Technical Bulletin

Bulletin Number: 142 Revision Number: R-02

SUBJECT: **INSTALLATION OF JUMPER WIRE ASSEMBLY**
PART NUMBER B172,010,200.03

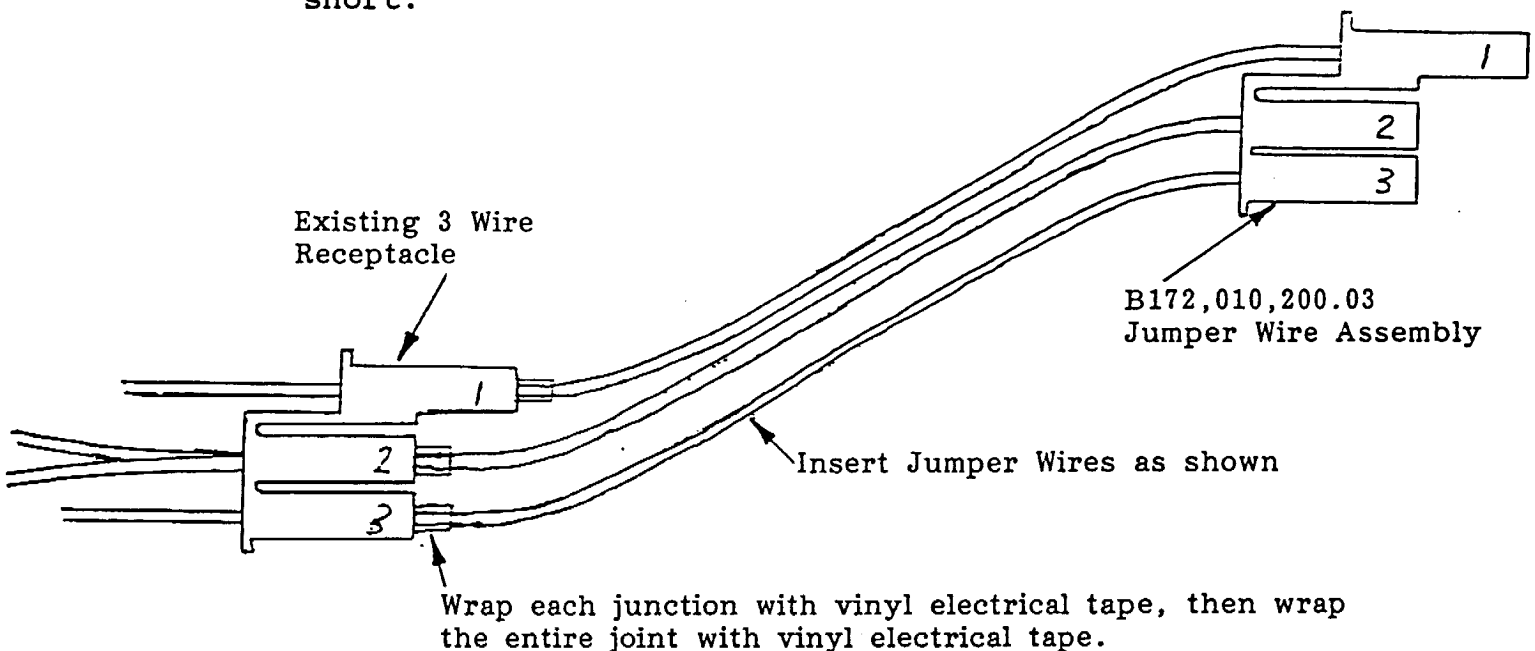
REASON: To provide a "Jumper" for (a replacement) Vend Motor Sub-Assembly with the "bottom mounted" hold switch since on the models serialized as above, the existing wiring harness is too short.

Do This: After the Motor Assembly has been changed, attach the Jumper Wire Assembly to the existing three wire receptacle (as shown), wrapping each connection with Vinyl Electrical Tape (Dixie Narco Part Number 902,302,900.01) then wrap the entire joint with vinyl electrical tape.
